**T-053 SERVICE BULLETIN**

**Rework of E6898785 Helical PTO Gearshaft**

<b>Engine Application(s):</b>	Allison 250-C28B, C28C, C30, C30L, C30M, C30P, C30R, C30R/1, C30R/3, C30S, C30U, C47B, C47M Series
<b>Subject:</b>	Rework instructions for E6898785 Helical PTO Gearshaft
<b>Compliance:</b>	Customer Option.
<b>Revisions:</b>	N/C Dated: 07/10/00 Initial Release. A Dated: 09/01/09 Updated EXTEX to TIMKEN. B Dated: 2/04/16 Updated Timken to EXTEX Engineered Products.

**Figure 1**

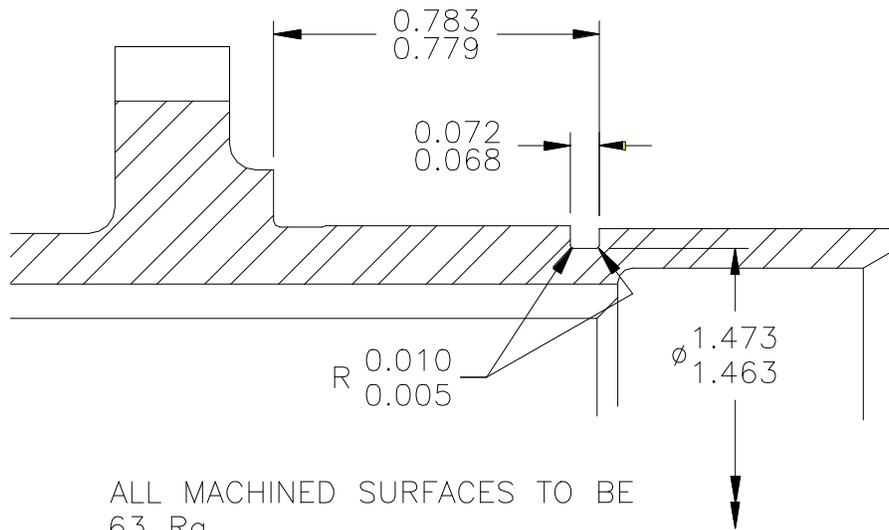
A groove is added forward of the roller bearing journal for a retaining ring. The retaining ring will secure the roller bearing inner ring to prevent it from moving axially off the journal during engine operation.

1. Comply with all OEM instructions pertaining to gearbox disassembly and Helical PTO Gearshaft removal.
2. Inspect Helical PTO Gearshaft per the applicable OEM Operation and Maintenance Manual to ensure suitability for rework.
3. Machine a groove in the bearing journal as shown in Figure 1. Upon completion of machining, it is optional to reapply black oxide to the newly exposed bare-metal surfaces; however, for parts that are not to be immediately installed in an engine, application of a corrosion inhibiting substance is recommended.
4. MPI the gearshaft per the applicable OEM Overhaul Manual.

5. Re-identify the reworked gearshaft P/N E6898785 to P/N E23068295 per AS478-2D1.
6. Install bearing inner race as required per OEM instructions. Install AS3216-124 retaining ring into the new groove forward of roller bearing inner race.
7. Install all components and reassemble gearbox per the appropriate OEM instructions.
